PCN-20201003 TE0890-01 SPI Flash Change

Company	Trenz Electronic GmbH
PCN Number	PCN-20201003
Title	TE0890-01 SPI Flash Change
Subject	BOM change
Issue Date	2020-10-06

Locate Flash (U6) at top side of PCB:

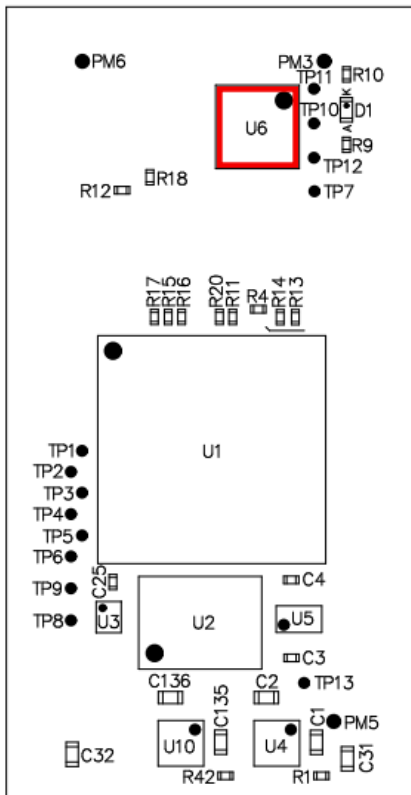
#1 Change SPI Flash from N25Q064A13ESE40F to IS25LP064D-JBLE

Impact: JEDEC ID changes from BA17h to 6017h and manufacturer ID from 20h to 9Dh.

N25Q064A13ESE40F IS25LP064D-JBLE
